This gallery shows some pictures of bad solderings - they should prevent you from making the same errors (feel free to add even more pictures here!)

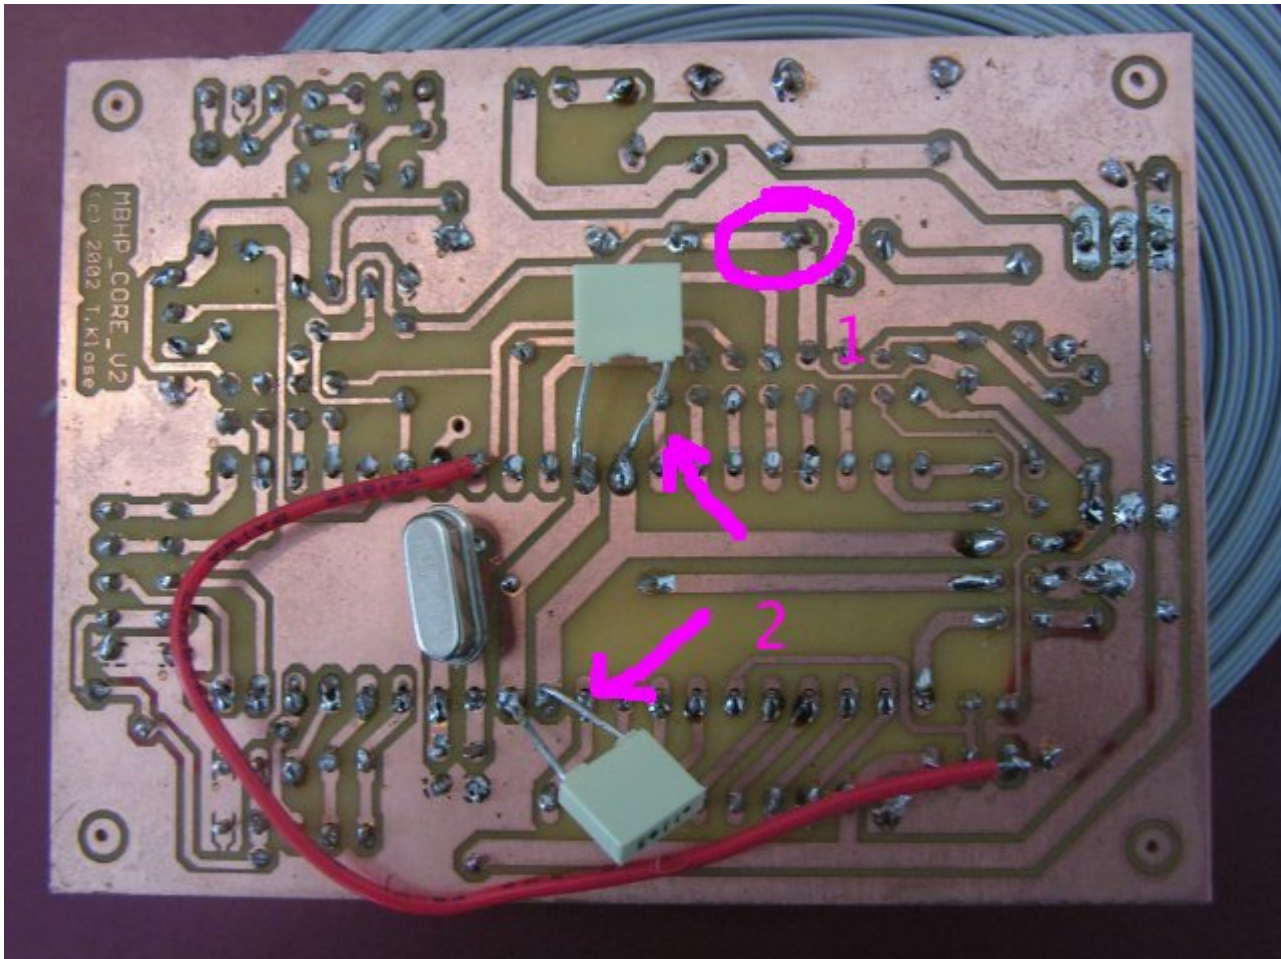
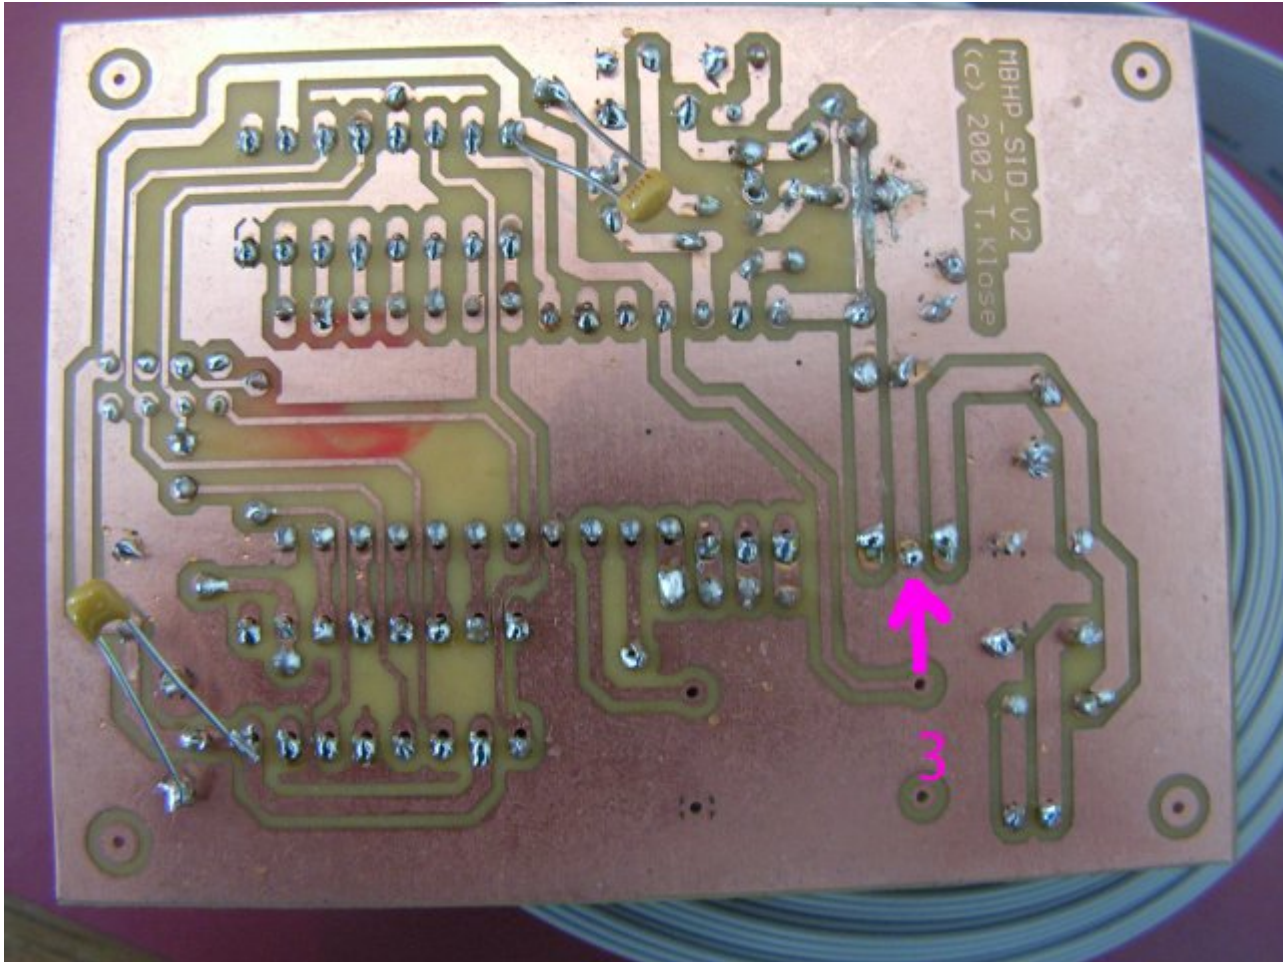
1: the core module has some bad solderings (loose connections), which could lead to failures. There are also missing solderings (e.g. 33pF cap below crystal). It makes sense to solder each pad again, the [Soldering](#) guide in the Wiki gives some useful tips

2: the legs of the caps should be cutted, otherwise they can cause a short circuit which can damage the PIC!

3: this seems to be a bad ground connection directly at the 78xx - it can lead to the wrong voltage. Here the same: just solder the pads again, it will help

And same like above: the long cap legs need to be cutted, the danger for shorts is too high!
